DSDD SHUGART SA850/851

2200LVP/SVP AND VS ARCHIVING WORKSTATION APPLICATIONS:  
CIRCUIT BOARD PART NUMBERS AND JUMPER CONFIGURATIONS

TOPIC: CORRECTION TO TAC NEWSLETTER 30208, CATEGORY III.A.II

FCO NO.  
1007

**FIGURE 2 VS-AWS JUMPER CONFIGURATION (MLC10)**

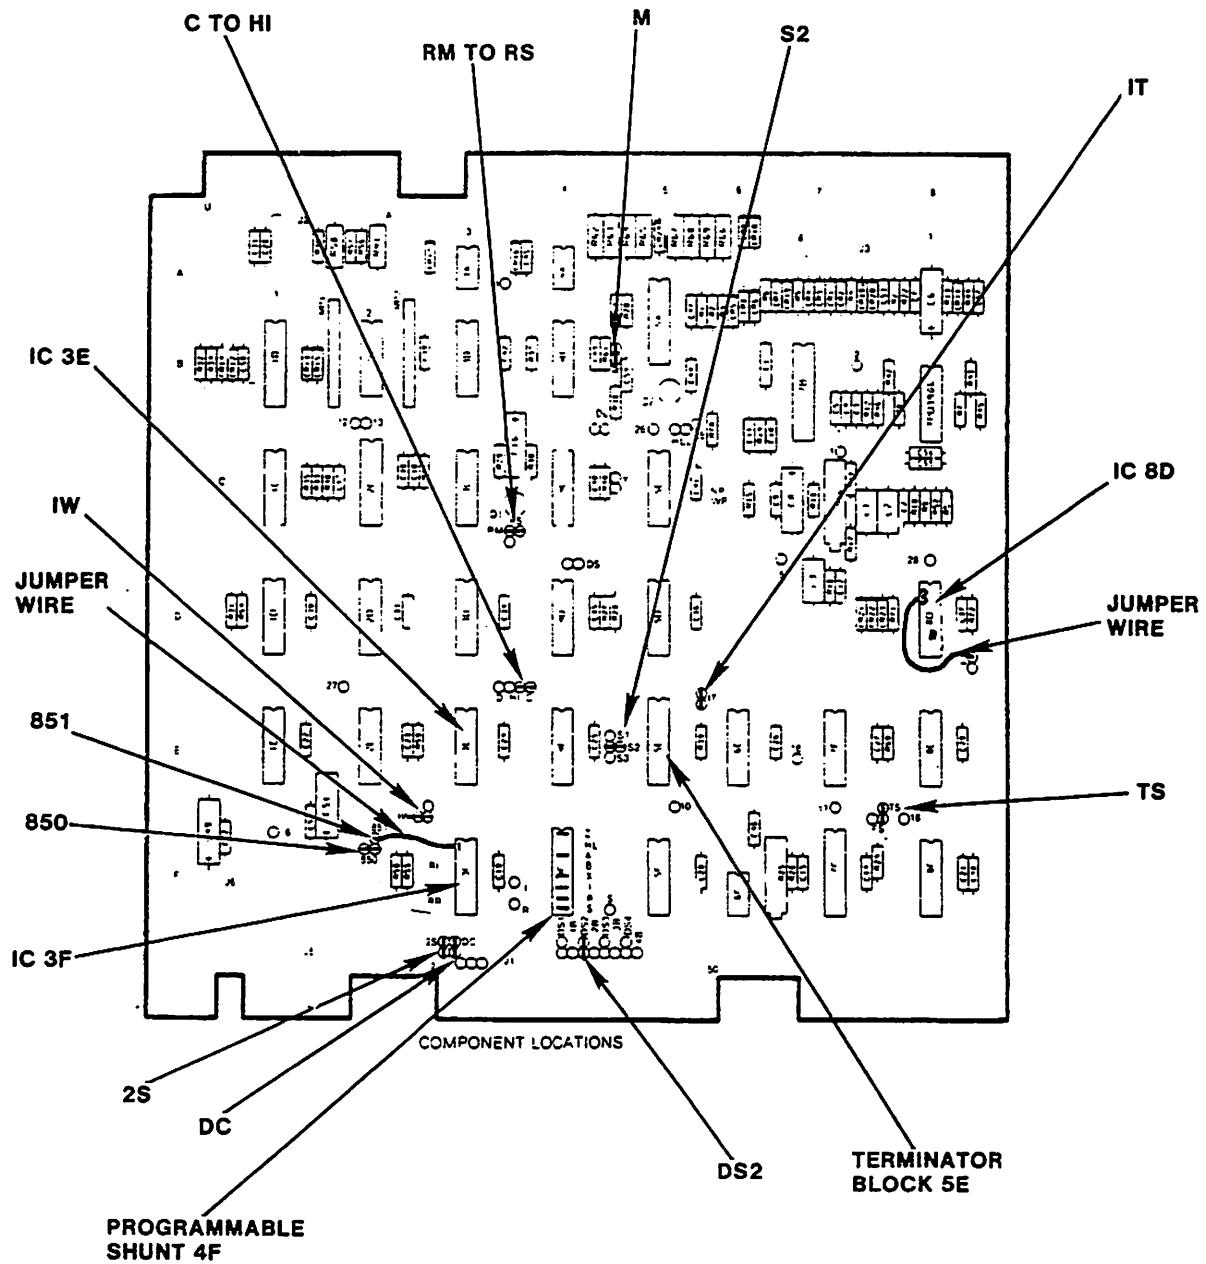
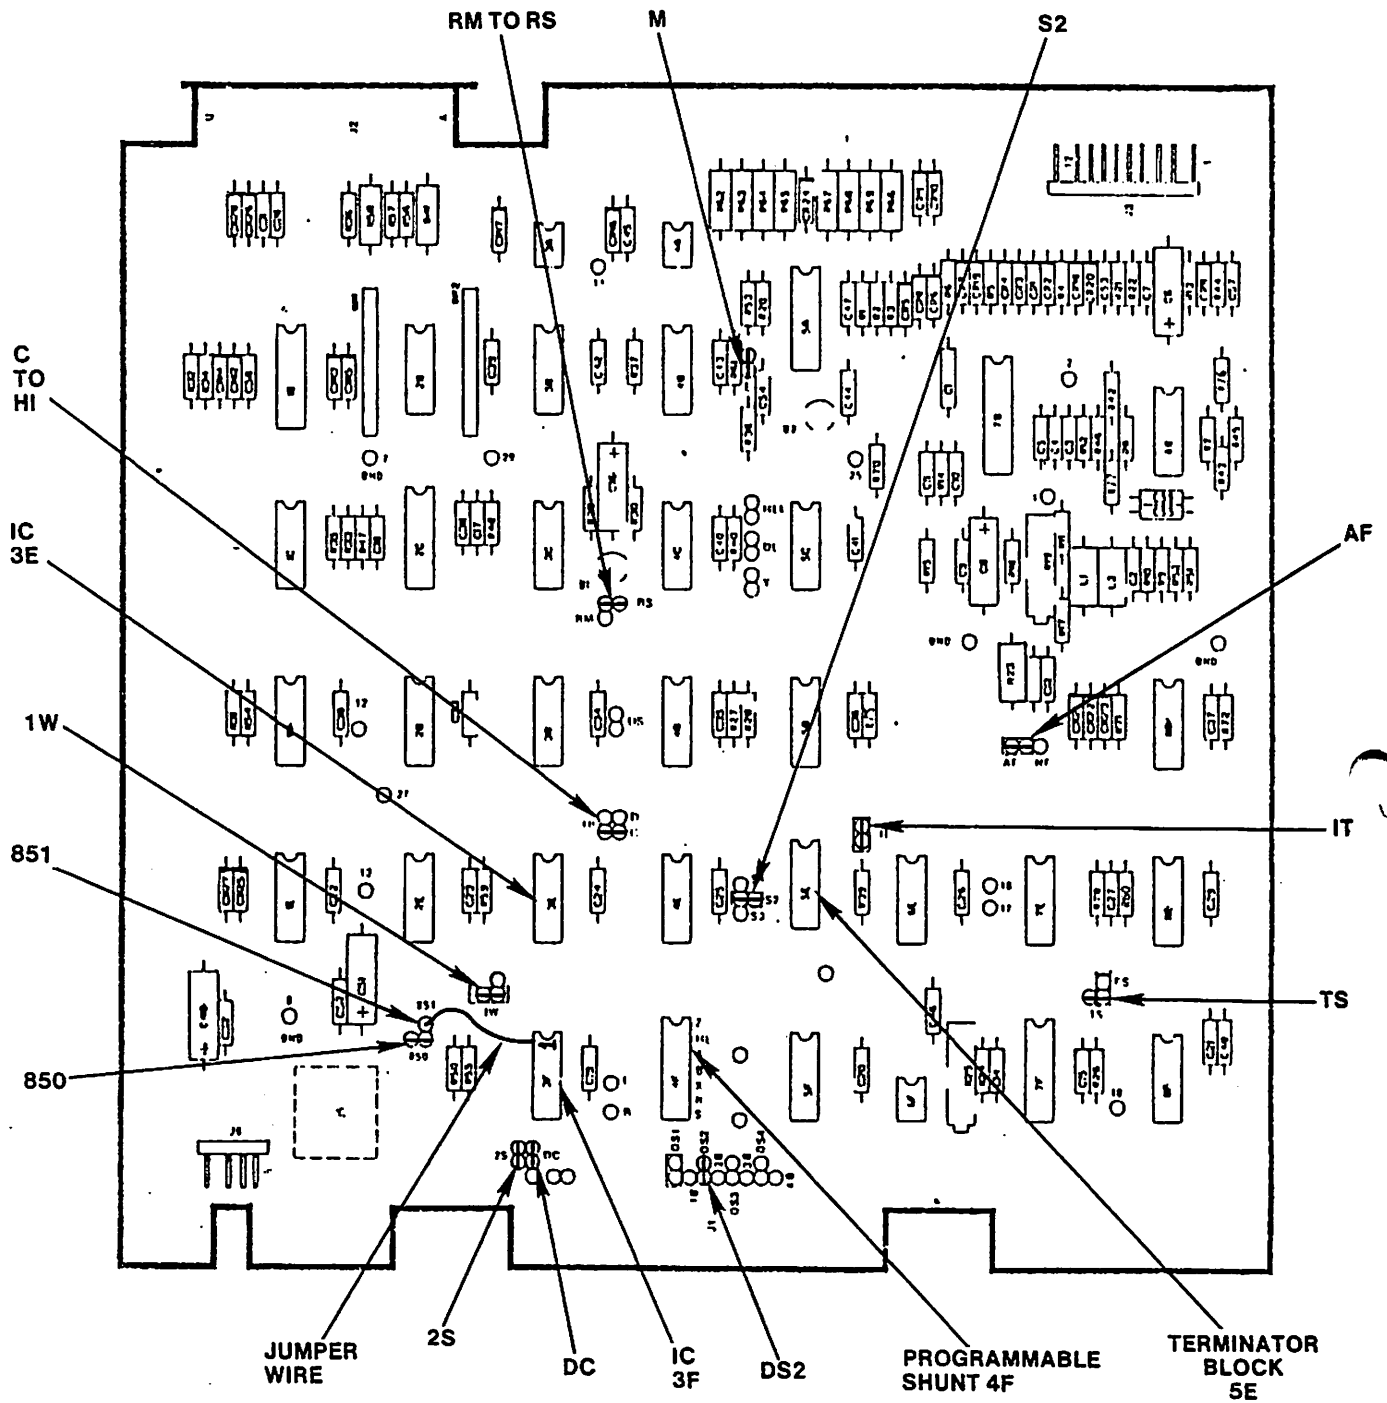
For VS-AWS operation only, the etch on the non-component side of the board between pin 8 of IC 3E and pin 1 of IC 3F must be cut and a jumper wire connected from pin 851 to pin 1 of 3F (see Figures 2 and 4).

ILLUSTRATION "A"

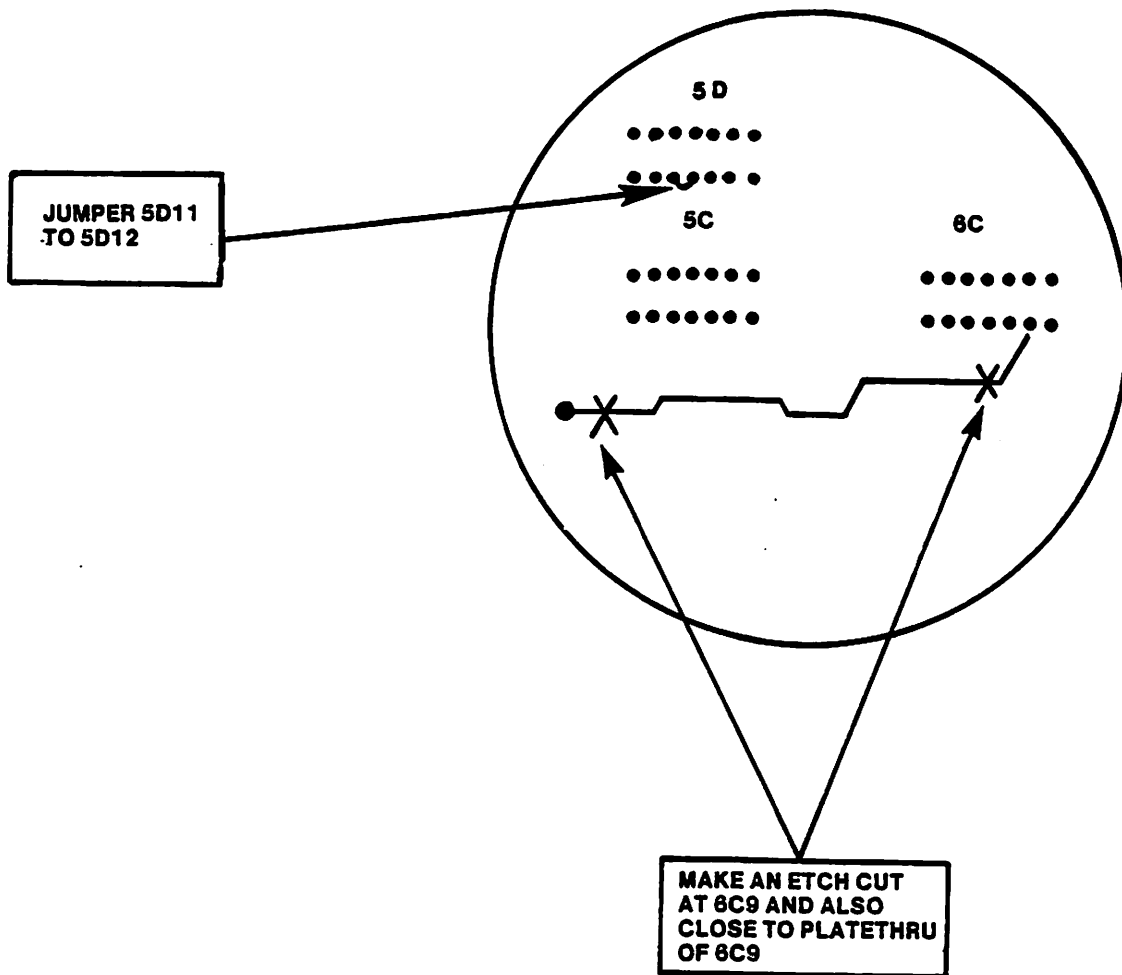
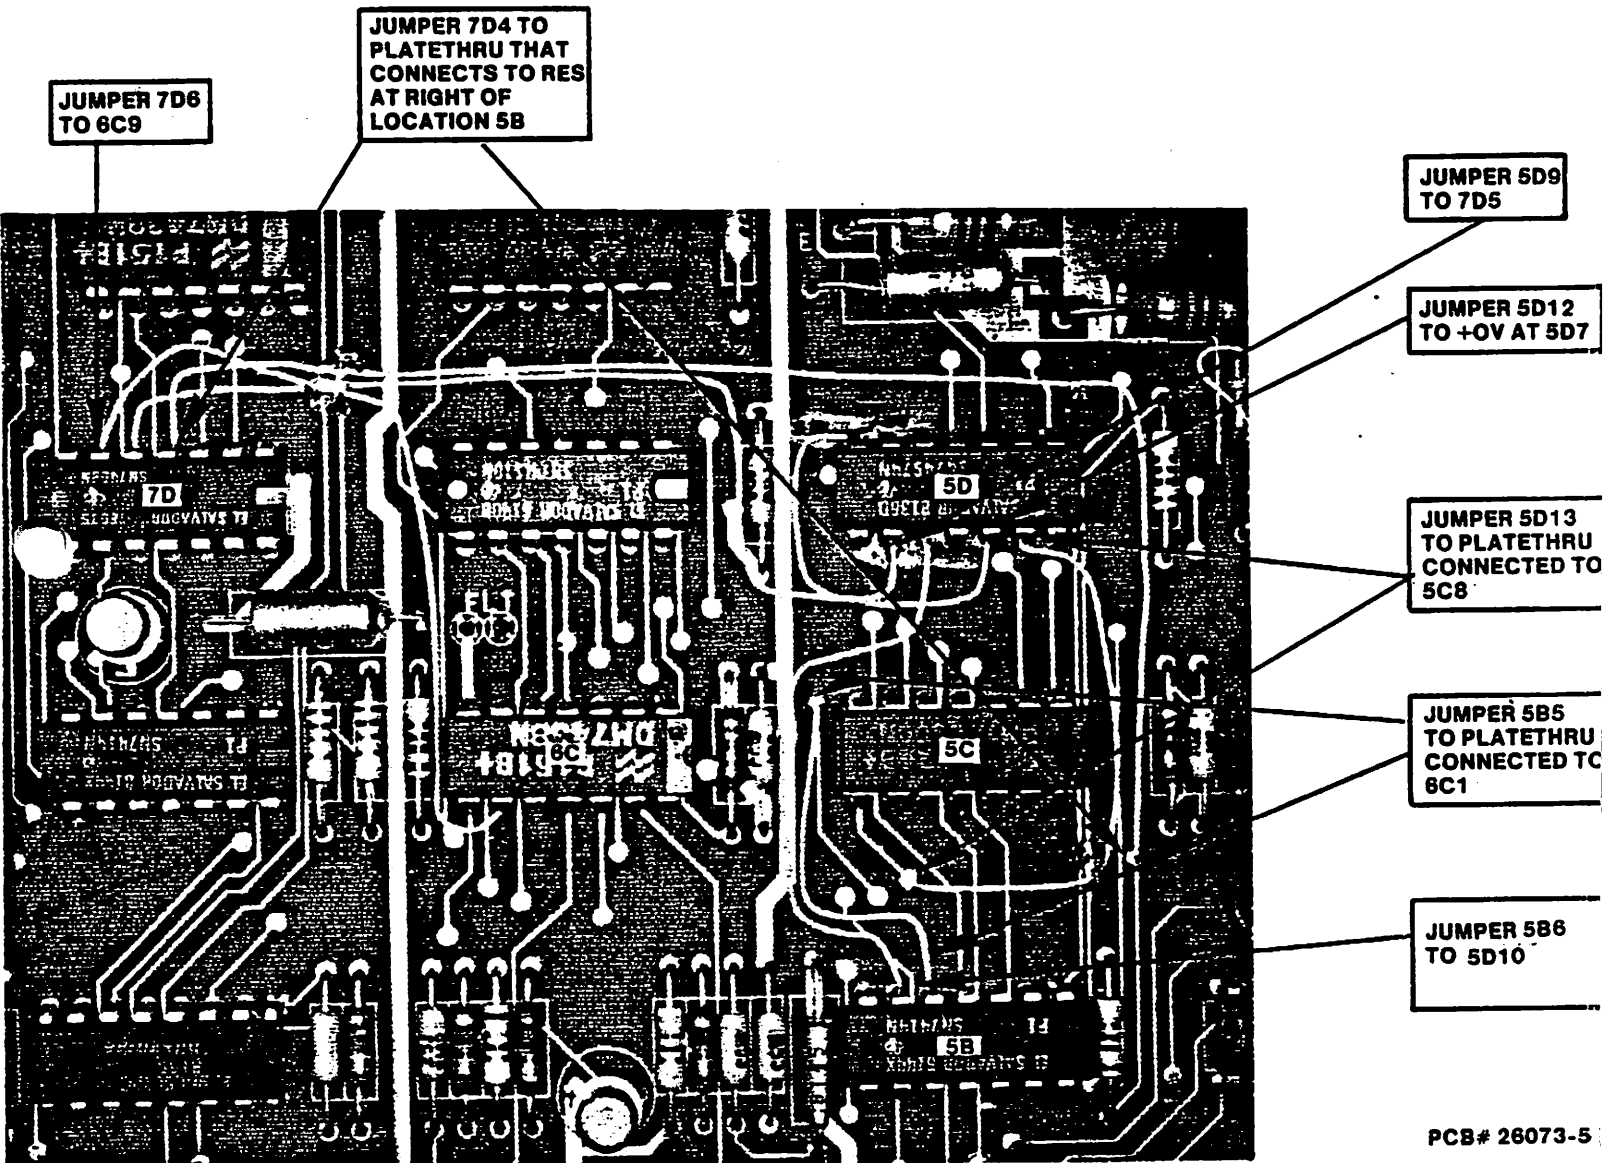
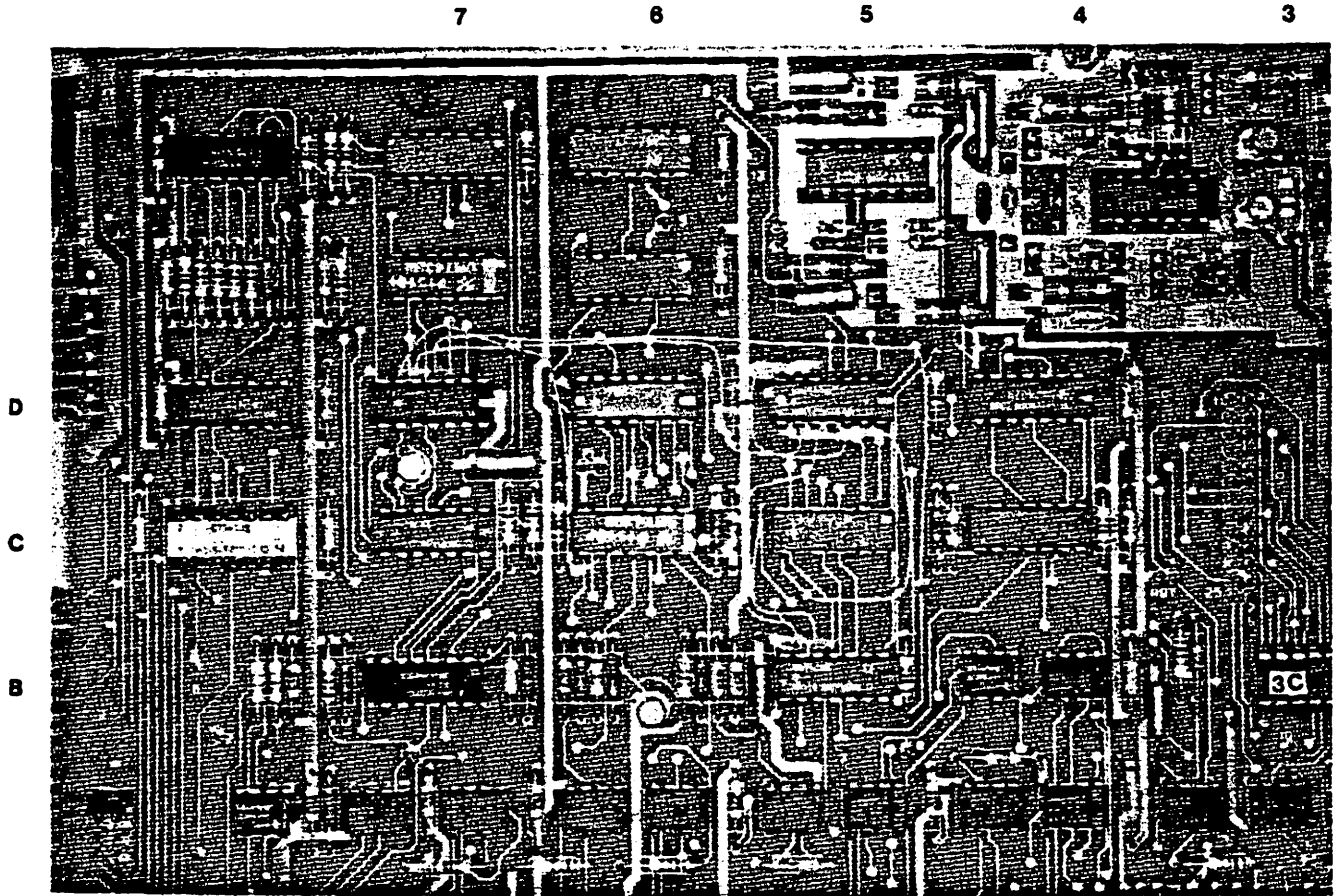
This change incorporates eight jumpers and two etch cuts (PCB# 26073-5) in order to perform AND operation on "SEEK COMPLETE" and "TRK00" signals.

- F. Make an etch cut at 6C9 and also cut the same etch close to platethru of 6C9. (See Illustration A)
- G. Jumper 5D11 to 5D12. (See Illustration A)

- H. Jumper 5B5 to platethru connected to 6C1.
- I. Jumper 5B6 to 5D10.
- J. Jumper 5D9 to 7D5.
- K. Jumper 5D12 to +0V at 5D7.
- L. Jumper 5D13 to platethru connected to 5C8.
- M. Jumper 7D4 to platethru that connects to the resistor at the right of location 5B.
- N. Jumper 7D6 to 6C9.
- O. After installation of this change, cross out the previous ECO# stamped on the bottom left corner of the PCB and mark the board with ECO# 3385.
- P. Remount board to drive with screw saved from Step E. Turn nylon locking devices to horizontal positions and reconnect cables as described in Step E.
- Q. Secure drive to chassis frame using the two bolts saved from Step B.
- R. Turn on power.
- S. After testing system integrity, turn off power and reinstall the top cover.
